FIELD REPORT

PROJECT: Contact Tank
 Greenburgh, NY

FIELD REPORT NO: 05
ENGINEER'S PROJECT NO: 99010

Work in Progress: Selective Demolition of the Contact Tank Roof Slab

Photo No. 1 – East Side – Measuring Bar Position

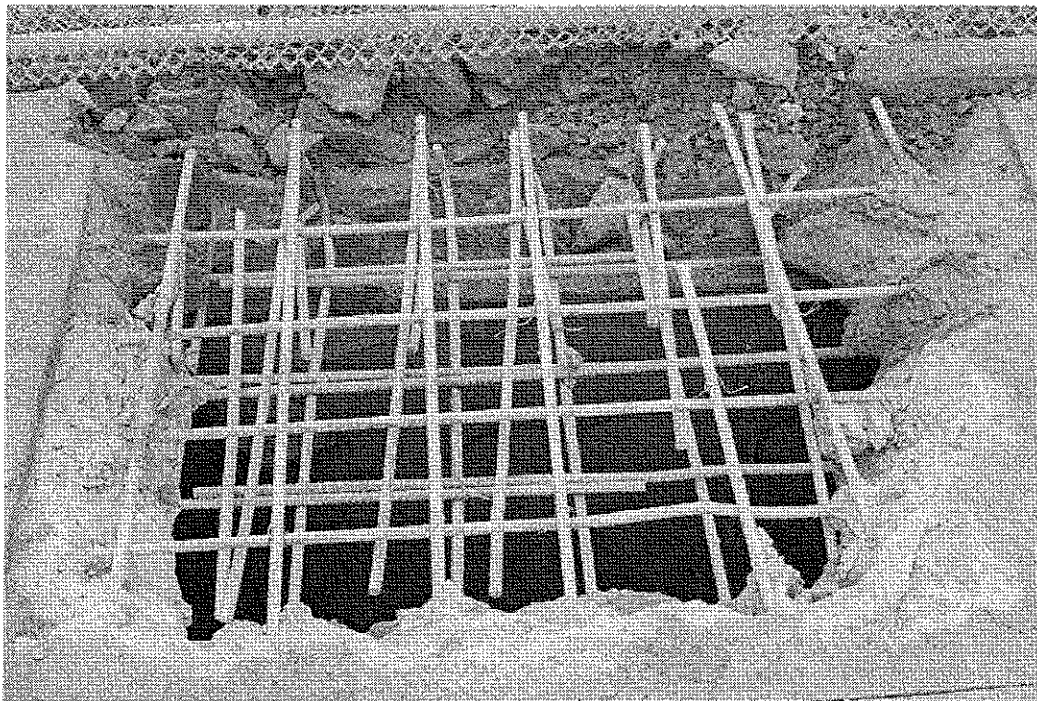
of the reinforcing bars. Clearances from the top of the slab to the top of the reinforcing bars was determined by placing an 8'-6" long strait edge parallel to the edge of the tank supported by the edges of the hole and measuring from the bottom of the straight edge to the top of the bar using a steel rule. (See Photo #1.) Clearances from the inside face of the wall to the wall reinforcing bars were measured using an adjustable square.

Photo No. 2 – East Side Bar Arrangement

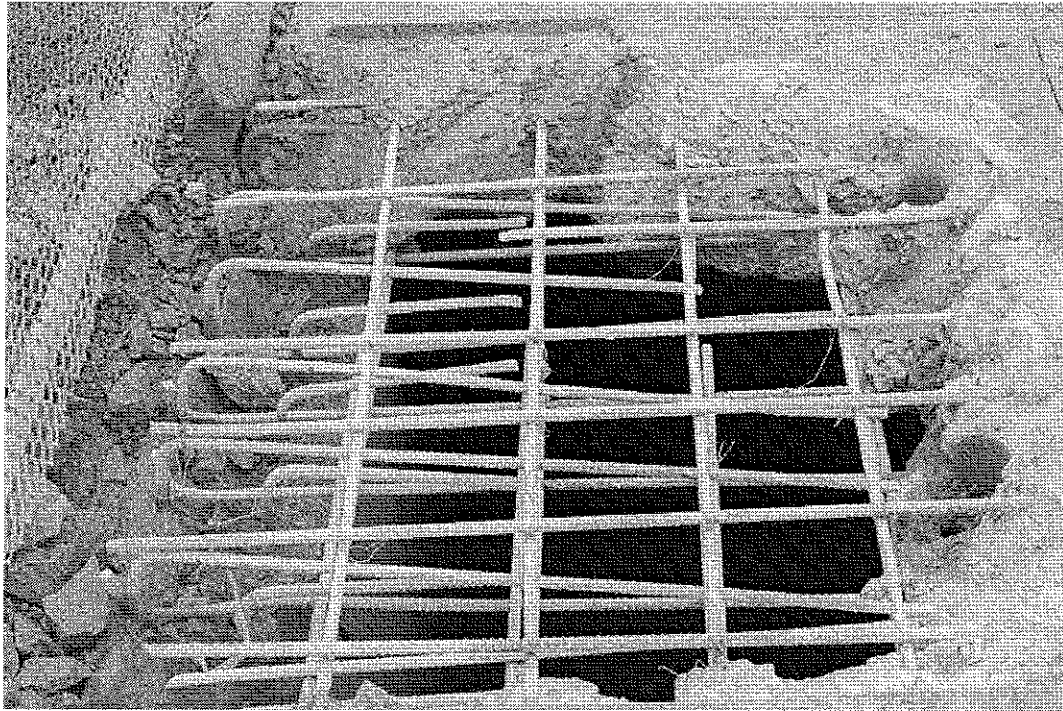
We found that the reinforcing bar placement that was observed did not conform to the contract drawings. While the bar size and spacing did conform to the drawings, we found that the clearances between the reinforcing bar and the concrete surfaces did not conform to the contract drawings. These findings are shown on sketches SK 040404-1, SK 040404-2, SK 040404-3 and SK 040404-4. The dimensions that are shown on these sketches are the averages of the dimensions taken to each bar in each area. (See photo #2 through #7 for the arrangement of the reinforcing steel.)

The bottom slab bars were set approximately 2 1/2" above the bottom of the slab and the hooked end of the bar was set approximately 2 to 2 1/2" from the edge of the slab. The contract drawings showed that the correct clearance should be 1 1/2" in both of these cases. The hook at the end of the bar at the east side was not the correct length. This hook was correctly detailed as a standard hook, 8" long on the shop drawings. The hook of the bar that was installed was only 5 1/2" long. There was no longitudinal in the hook of the rebar as shown on the contract drawings.

Photo No. 5 – West Side Bar Arrangement

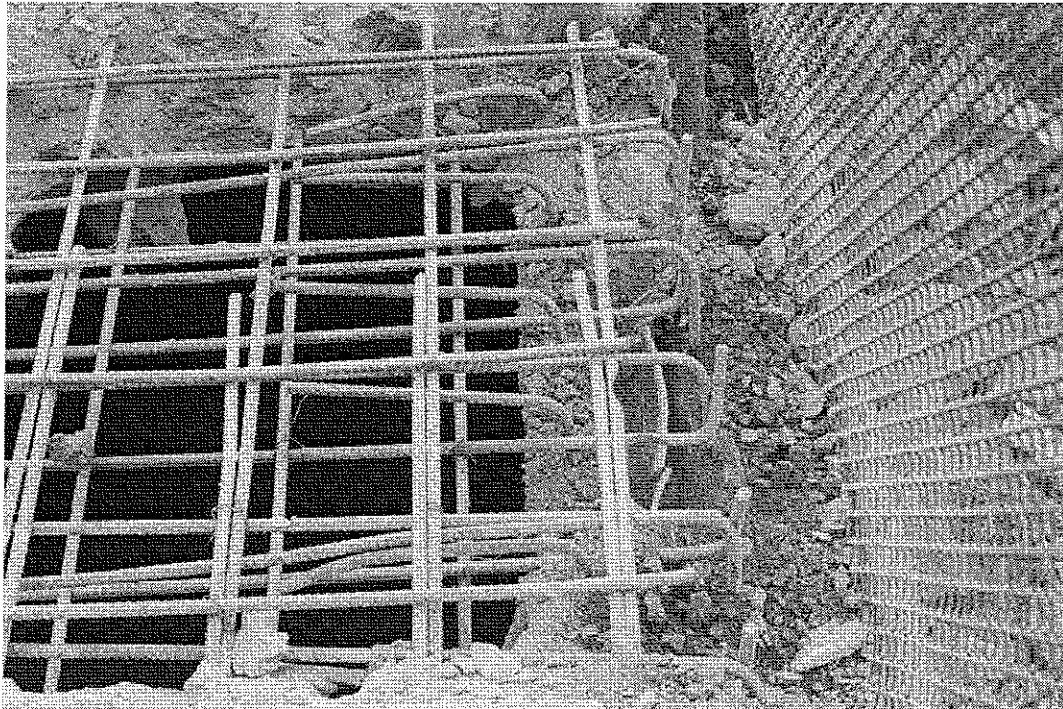
The top slab bars were set down 2.18" and 2.65" from the top of the slab at the east and west side areas respectively. The contract drawings indicated that this dimension should be 1 1/2".

Photo No. 6 – West Side Bar Arrangement

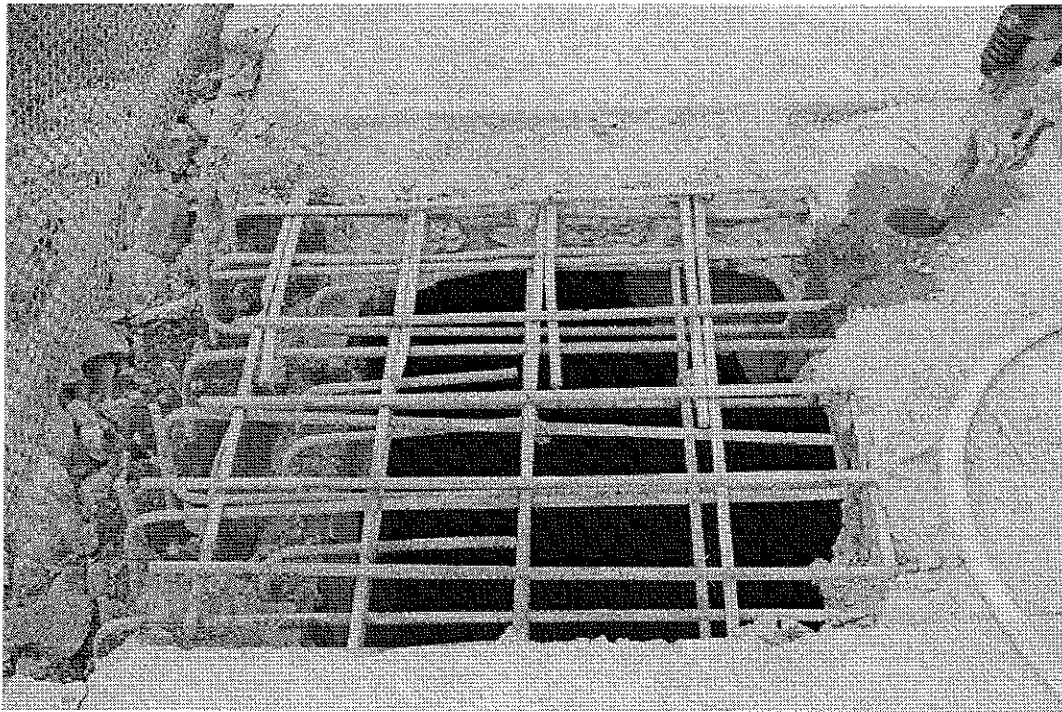
The inside wall bar was set back 3.1" and 1.85" from the face of the wall at the east and west side areas respectively. This dimension should have been 1 1/2". The top of the hook of this bar was set down 5.83" and 6.85" from the top of the slab at the east and west sides respectively. The contract drawings indicated that this dimension should be 1 1/2". There was no longitudinal in the hook of the rebar as shown on the contract drawings.

Photo No. 7 – West Side Bar Arrangement

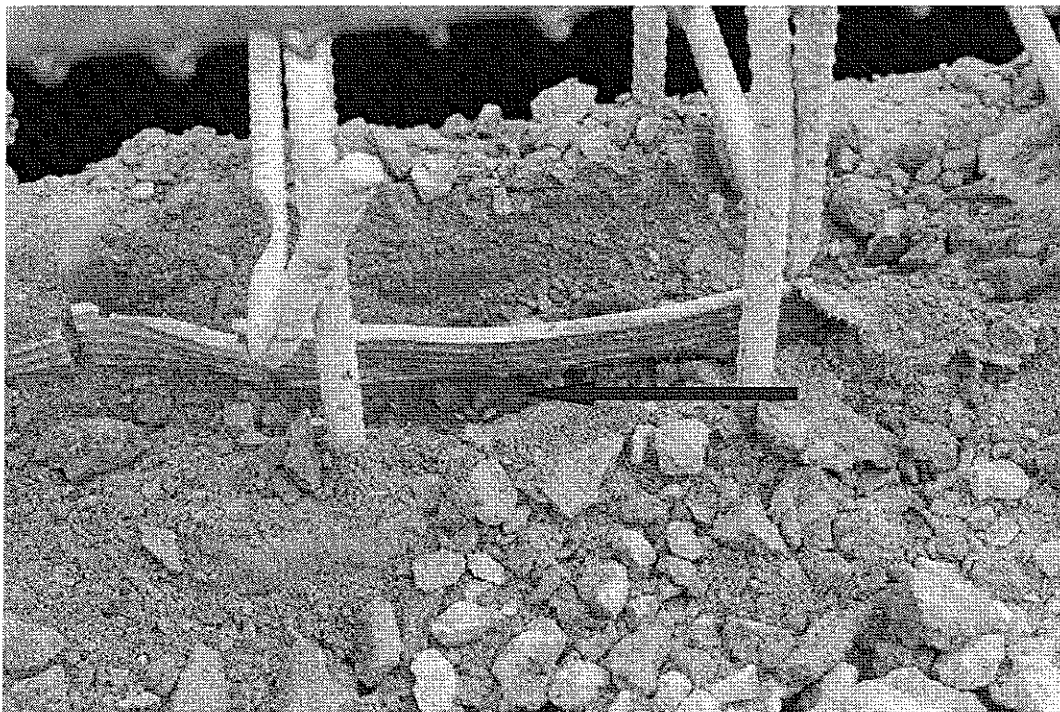
The outside wall bars were set back 2.38" and 1.98" from the outside face of the wall and the top of the hook of these bars were set down 3.29" and 4.35" from the top of the slab. The contract drawings indicated that these dimensions should be 1 1/2". There was no longitudinal in the hook of the rebar as shown on the contract drawings.

Photo No. 8 – West Side – Soil in Construction Joint

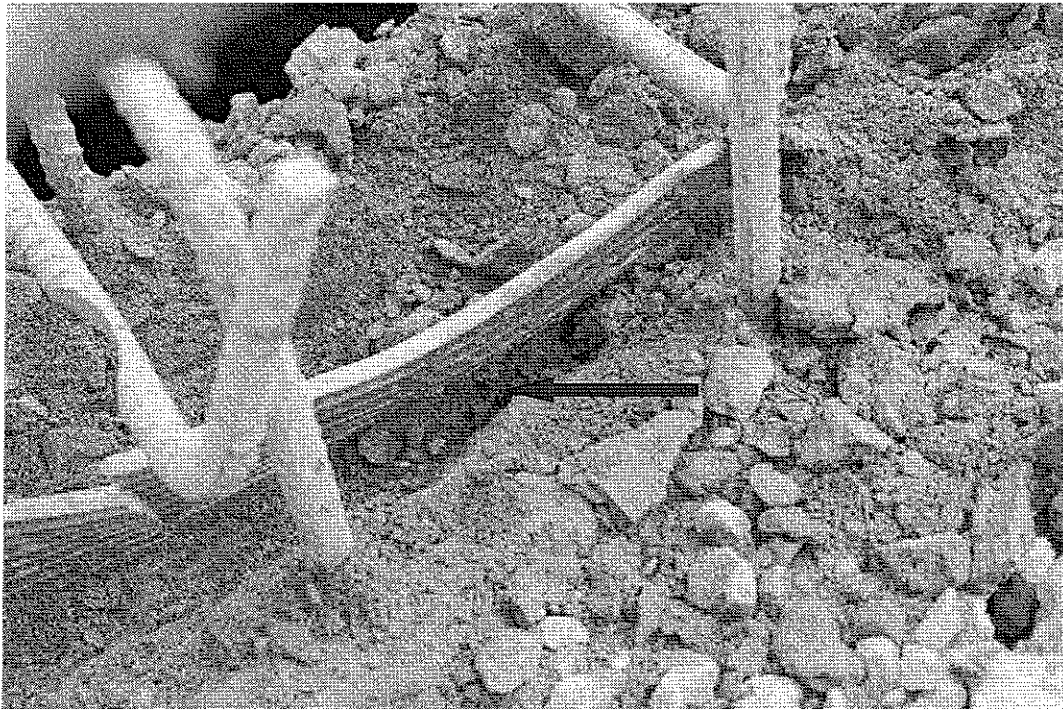
We found that the water-stop at the east side was folded over at approximately 45 degrees in one area. We also found that clods of dirt had been encapsulated up against the water-stop by the concrete at the west side when the concrete had been placed. Both of these conditions would prevent the proper function of the water-stop. (See photo #8 for the impression of the folded over water stop at the east side and photo #8 and #9 for the clods of dirt at the west side waterstop.)

Photo No. 10 – Test Gage From Pressure Test

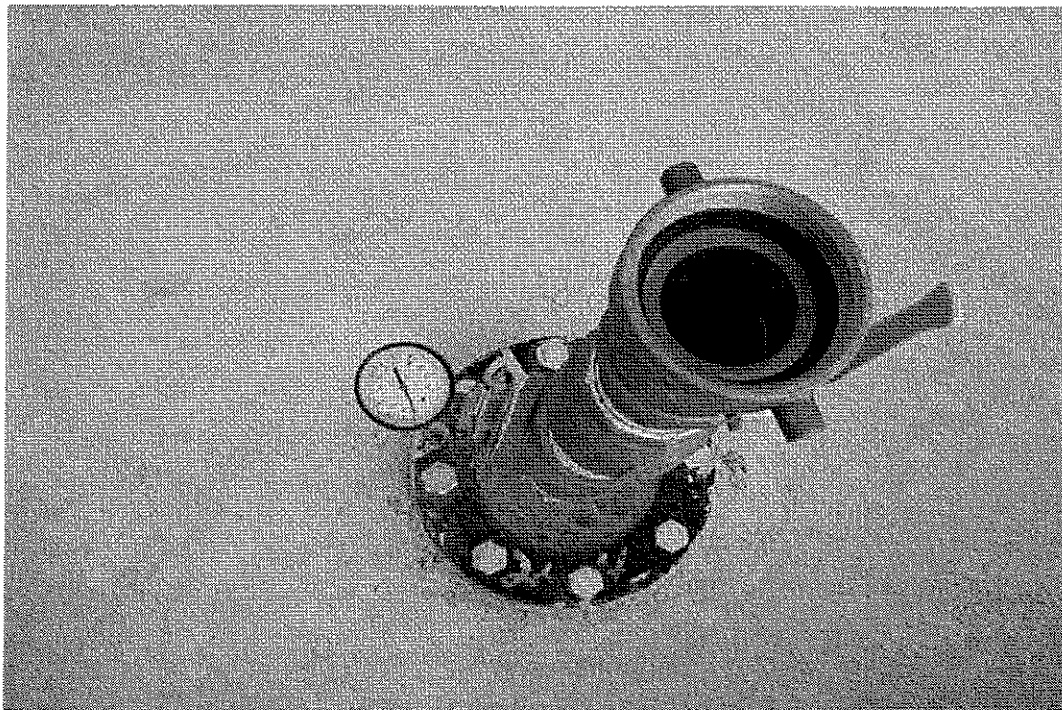
In discussions with Louie Ferrera on March 25 and 26, he revealed that during the pressure test that Spectra Serve conducted the test pressure may have reached 15 pounds per square inch which was greater than the test pressure. It should be noted that the gauge that had been used for the test has calibrated between 0 and 100 psi. and that during the test the needle that registered the pressure fluctuated erratically over a wide range of pressures. (See photo 10.)
